## ***Interactive comment on “Numerical mass conservation issues in shallow ice models of mountain glaciers: the use of flux limiters and a benchmark” by A. H. Jarosch et al.***

**A. H. Jarosch**

Received and published: 10 November 2012

**Fig. 1.** Replacement for Fig. 3 in manuscript which now includes the upstream scheme result as well

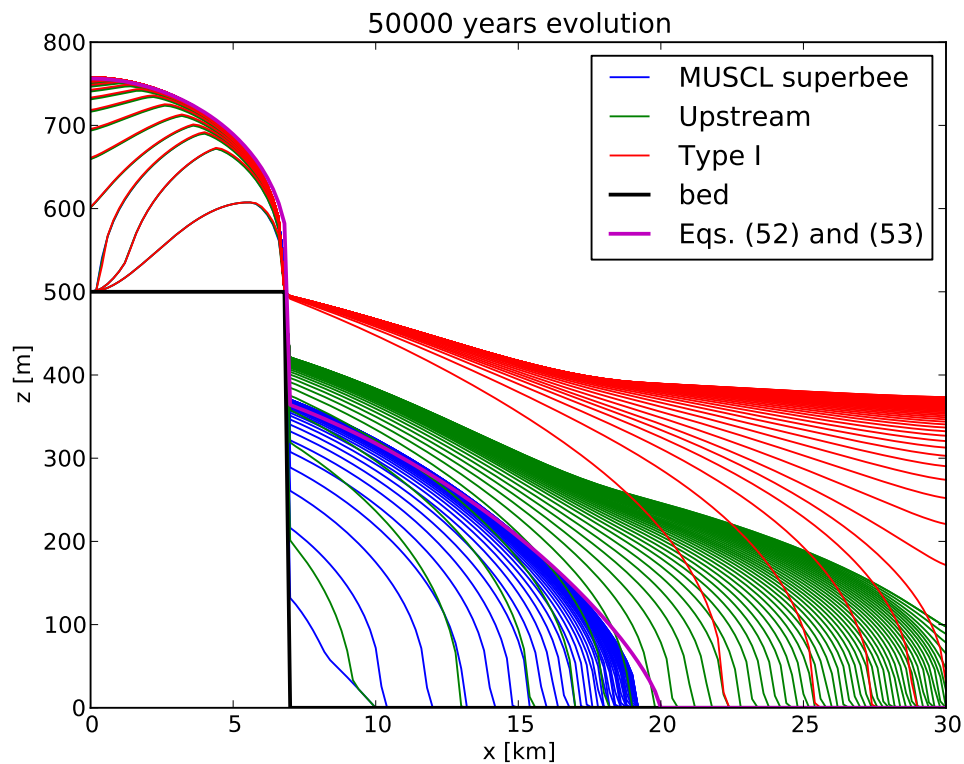
To evaluate the performance of an upstream scheme in comparison to our proposed MUSCL superbee scheme, I have implemented an upstream scheme such that the upstream ice thickness

as suggested by reviewer #1. The diffusivity at  $(k - \frac{1}{2}, l)$  is constructed accordingly. Our code example in the supplementary material (attached) includes now the upstream scheme computation for the same experiment as described in sect. 7.1 in our manuscript. Figure 3 in the manuscript will be updated to include the upstream scheme plotted in green and this new version is included here as Fig. 1.

In this experiment at 200 m horizontal resolution, the relative volume error for the upstream scheme  $RE_{vol} = 70.728 \%$ , for the type I scheme  $RE_{vol} = 146.000 \%$ , and for the MUSCL superbee scheme  $RE_{vol} = -1.012 \%$  (cf. Tab. 1 manuscript). Even though the upstream scheme performs better than the type I scheme it still fails the benchmark. Only the more complex MUSCL superbee scheme passes the benchmark and reproduces the explicit solution.
